MORGAN PLACE (FKA TRIANGLE PLACE) JZ19-17, JSP19-21

MORGAN PLACE JZ19-17 WITH REZONING 18.731

PLANNING REVIEW

1st revision: Rezoning Request from FS Freeway Service to B-3, General Business with Planned Rezoning Overlay

Sheet Title
EAST & NORTH ELEVATIONS

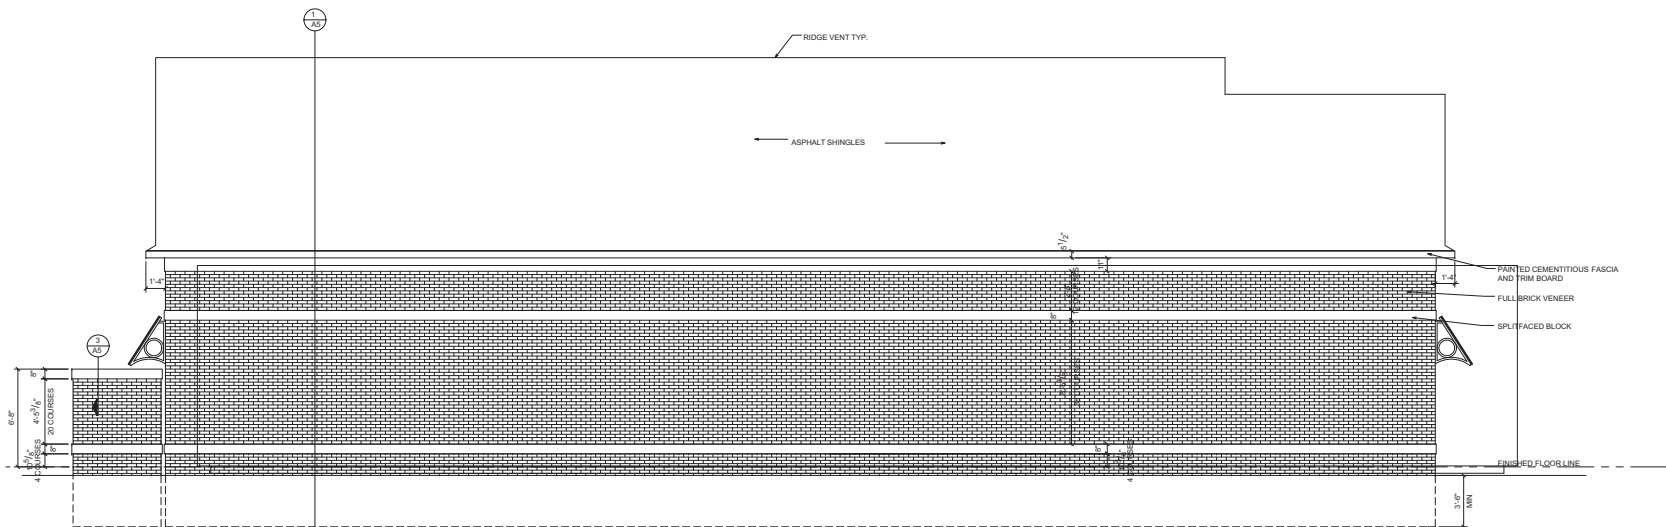
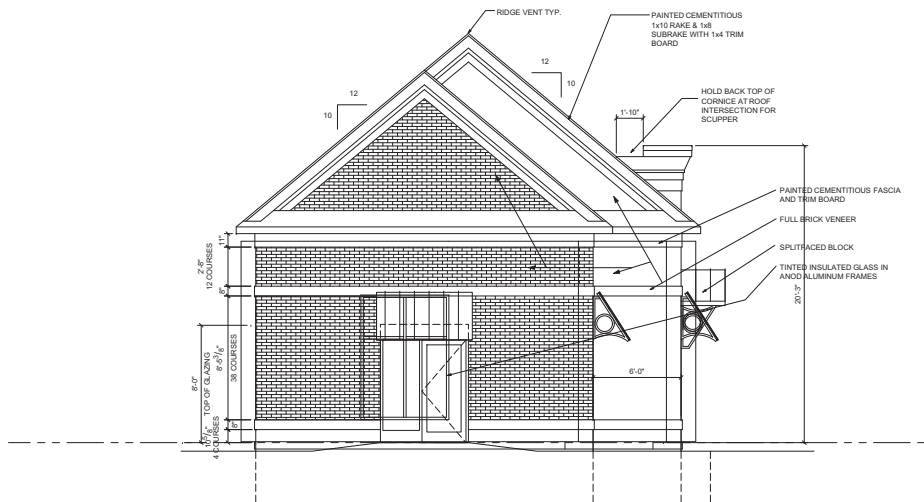
5. A section 9 waiver for overage of Asphalt shingles on the west and east facades (25% maximum allowed, 48% on West and 46% on east proposed), *because the proposed elevations meet the intent of the façade ordinance.*
